Drain: TIMBER HEIGHTS **Drain #:** 222
Improvement/Arm: WINDEN FOND - SECTION 2
Operator: JDM **Date:** 7-29-04
Drain Classification: Urban/Rural **Year Installed:** 1989

RE: Timber Heights Drain-Walden Pond Section 2 Arm

Re: **Timber Heights Drain - Walden Pond
Sec. 2 Arm**

CONSTRUCTION PLANS FOR
WALDEN POND
99th & WESTFIELD BLVD.

Lift Station Plan

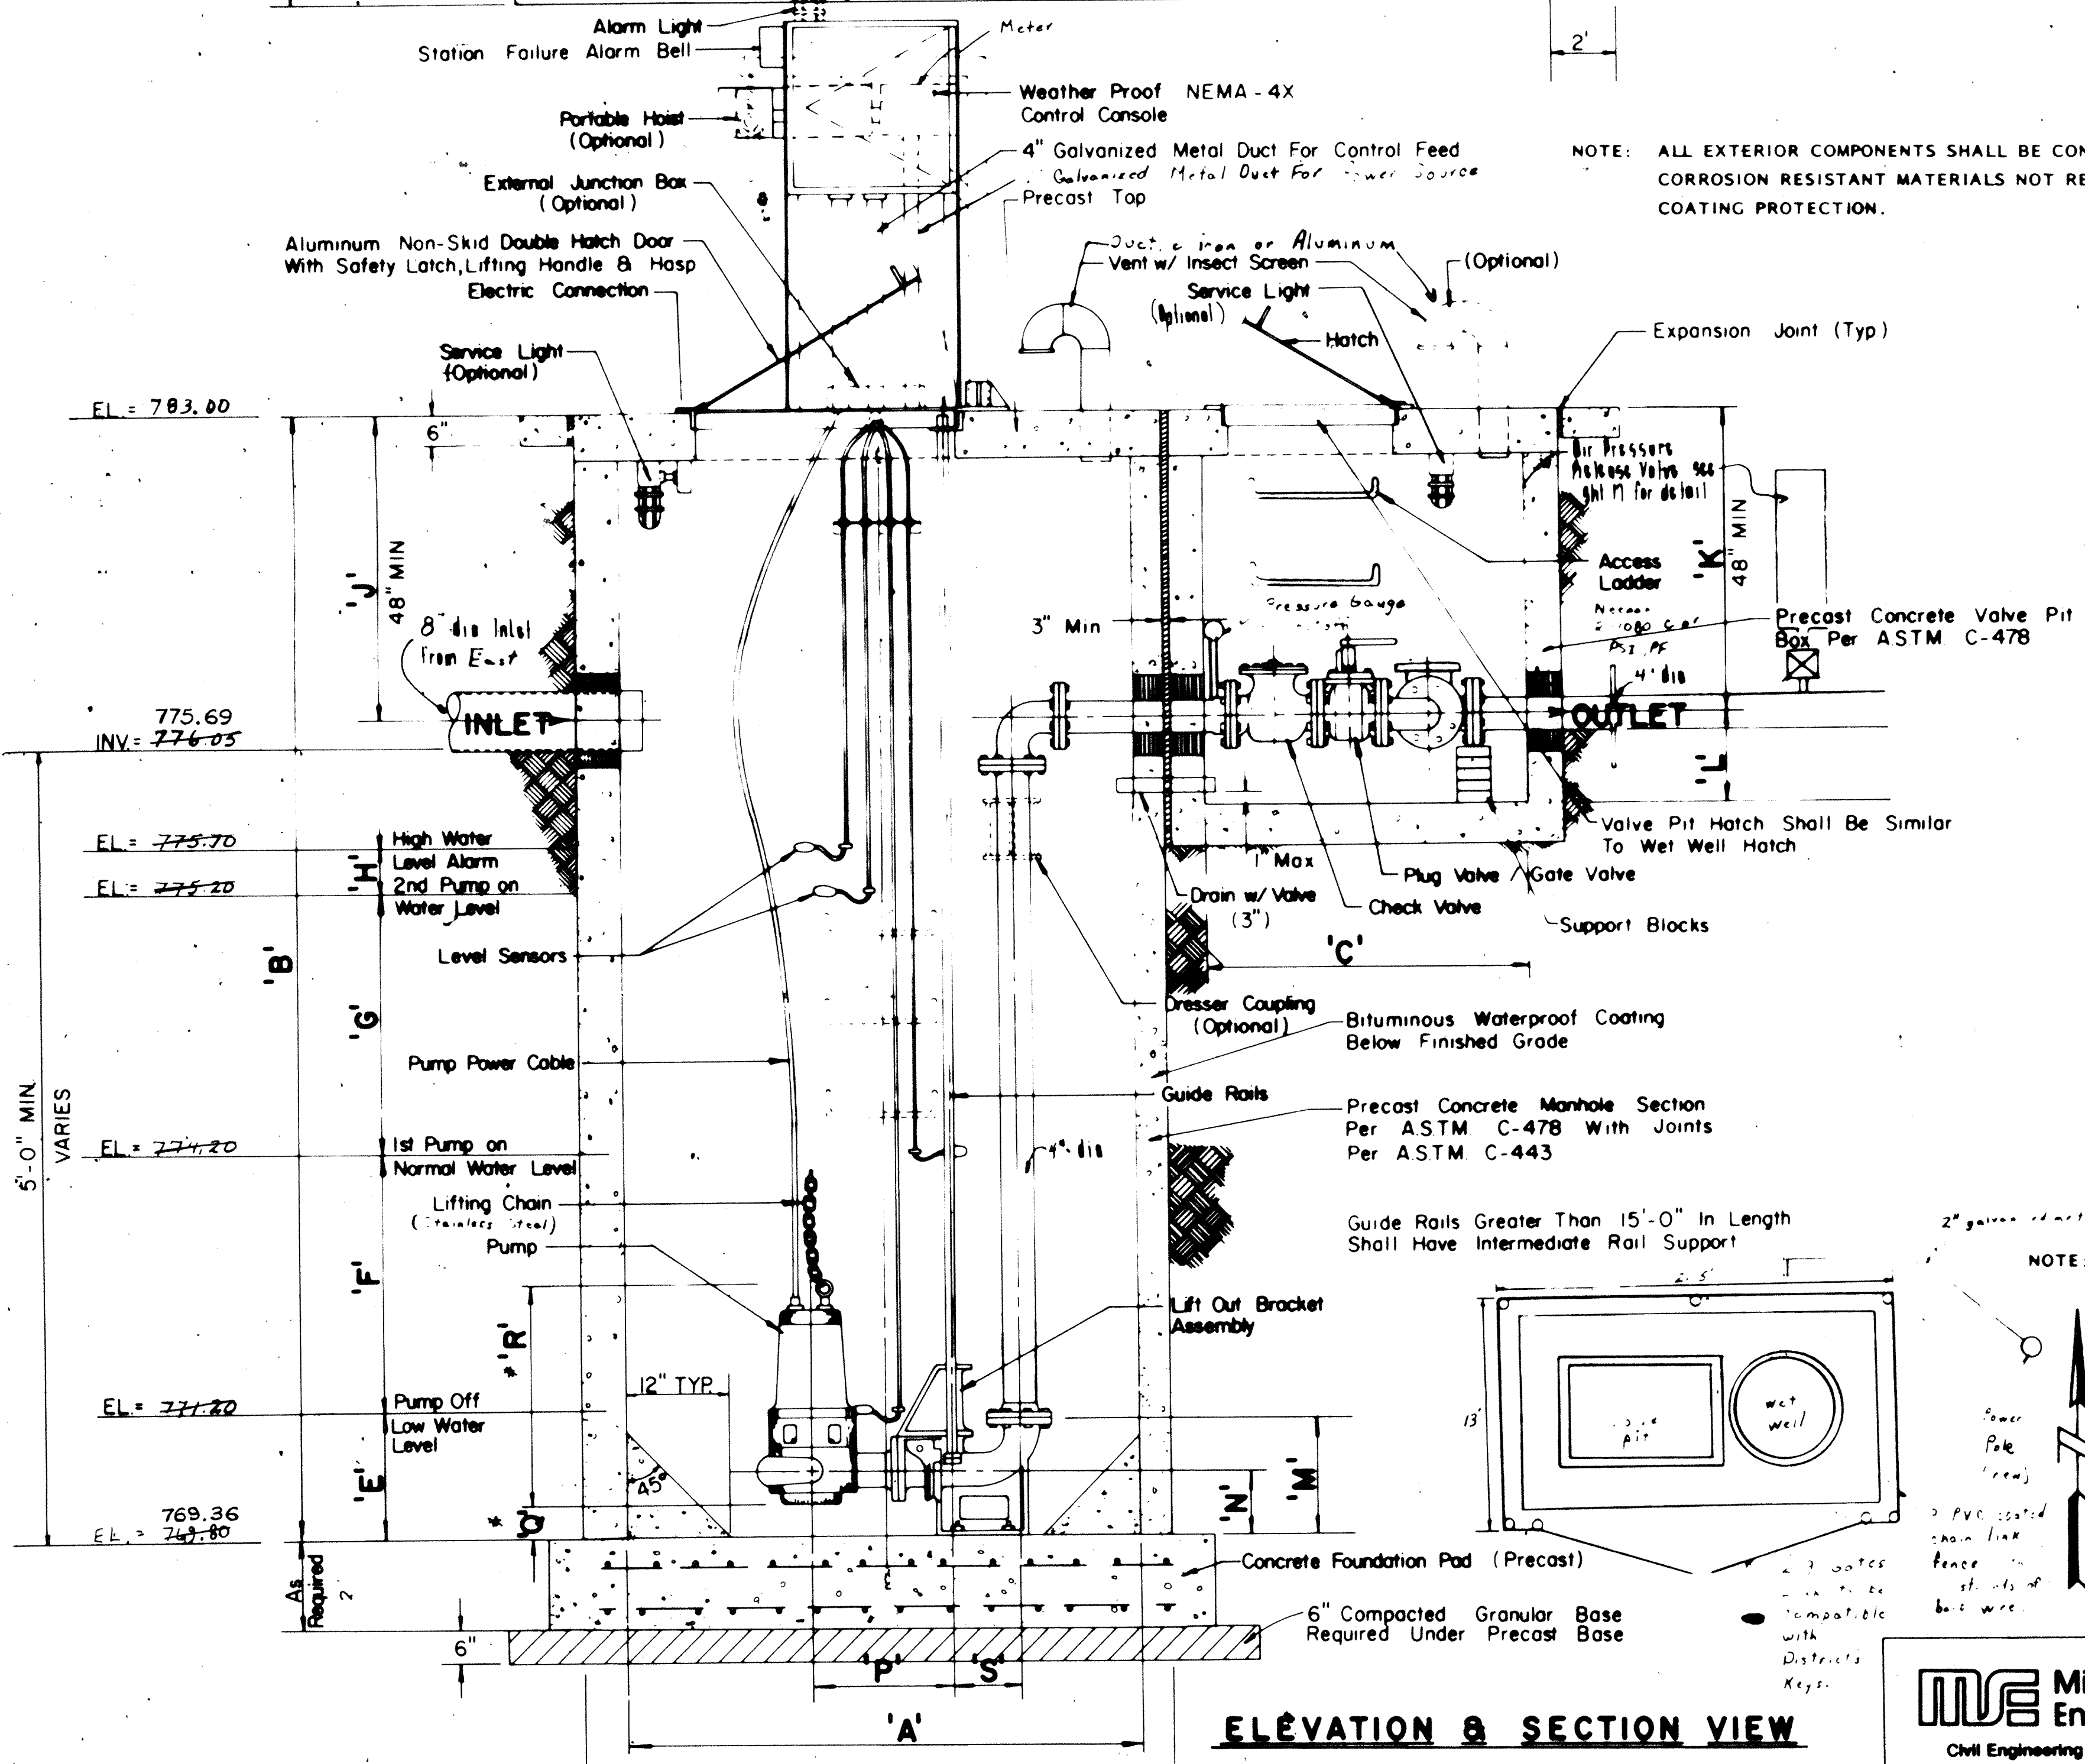
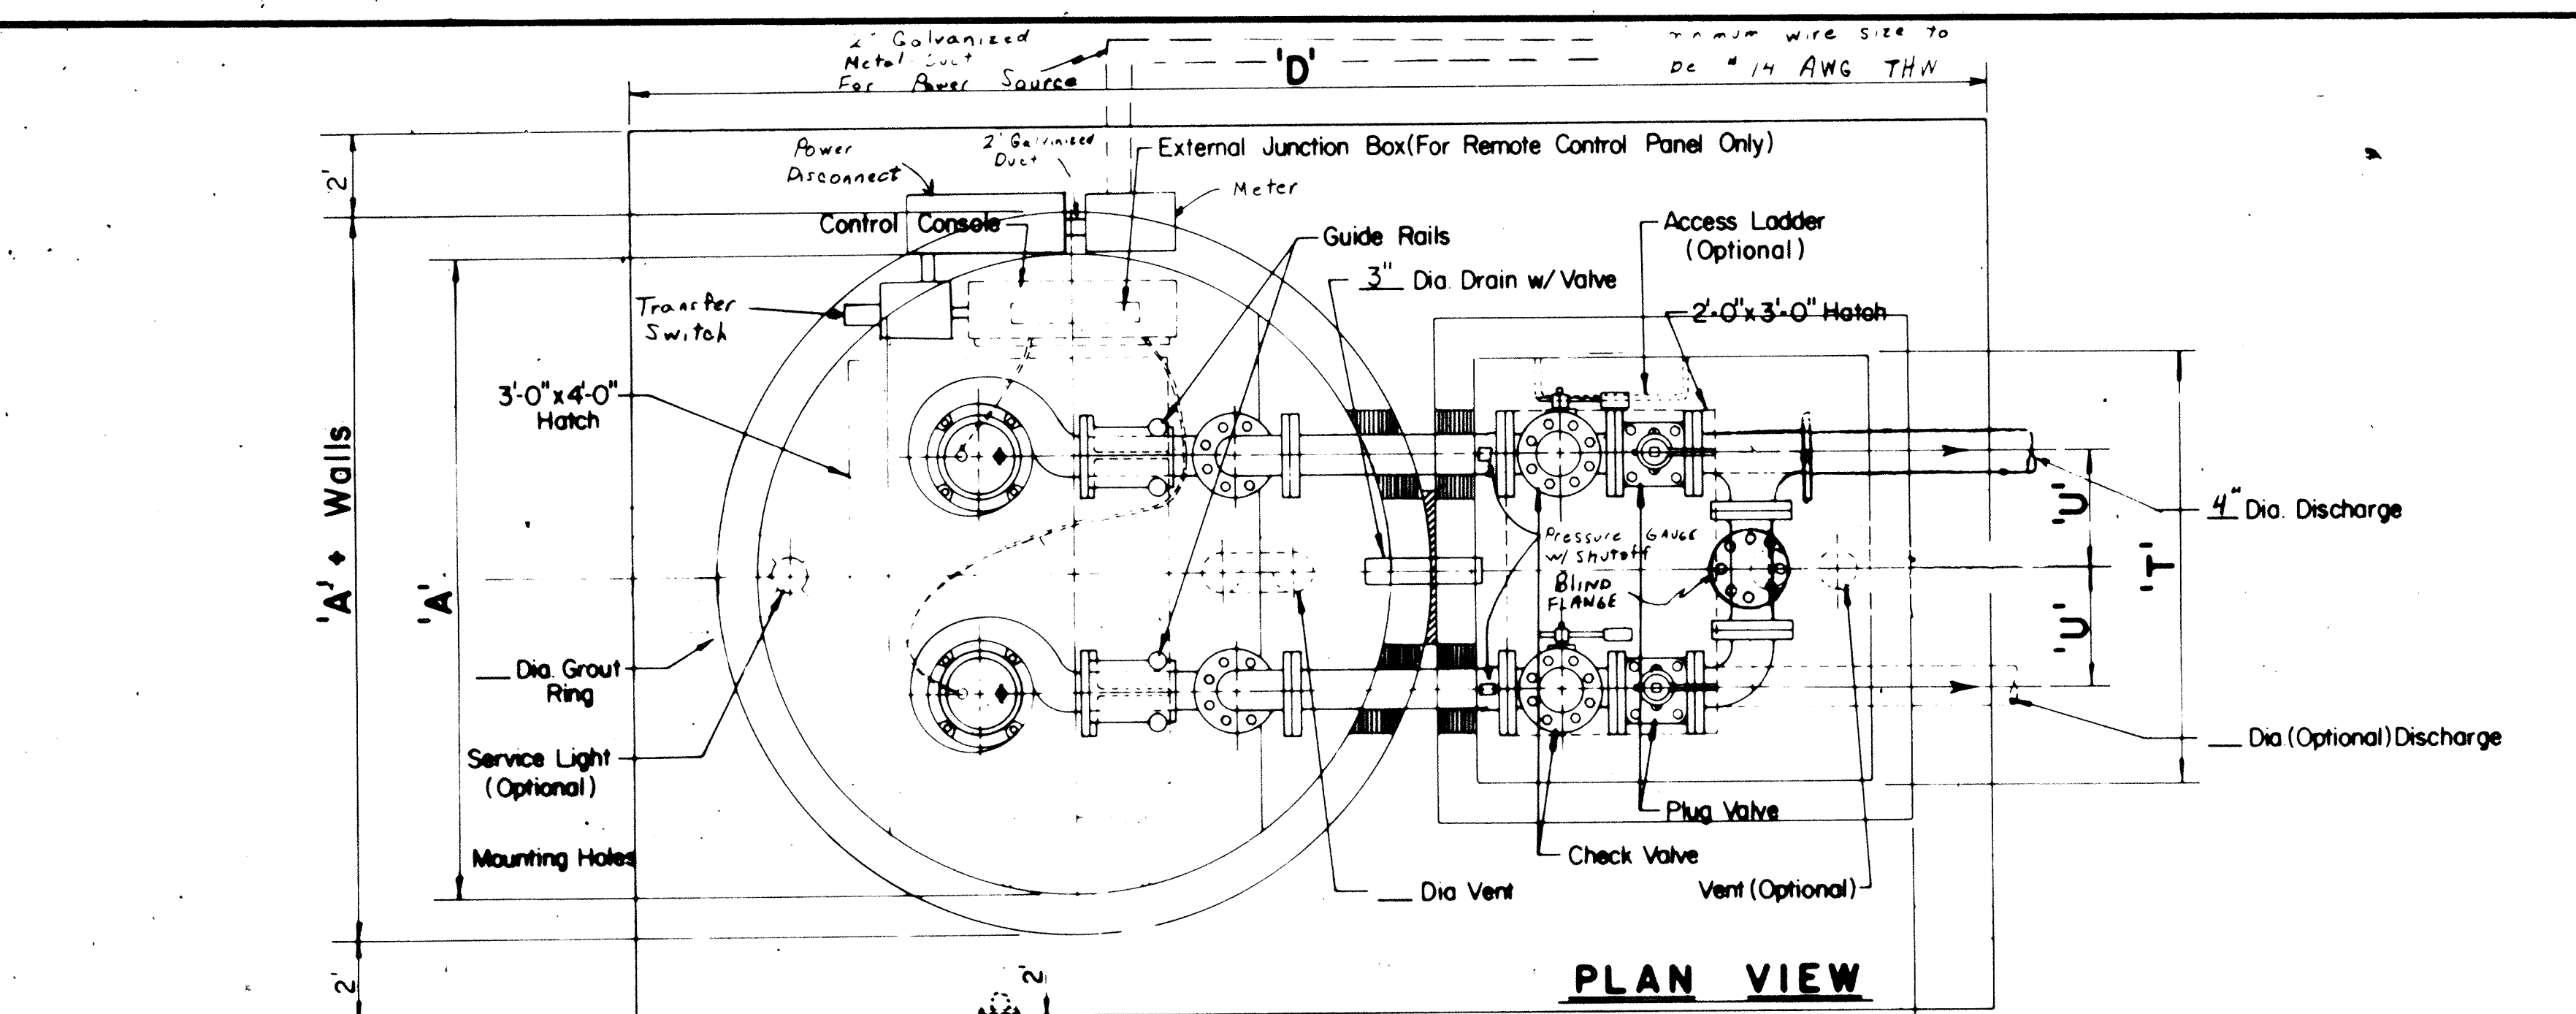
3-1-88 - rev ladder type, add pressure valve, increase valve pit size, add conduit locations, wire size, add fence location.

4-1-88 - rev vent material - add note
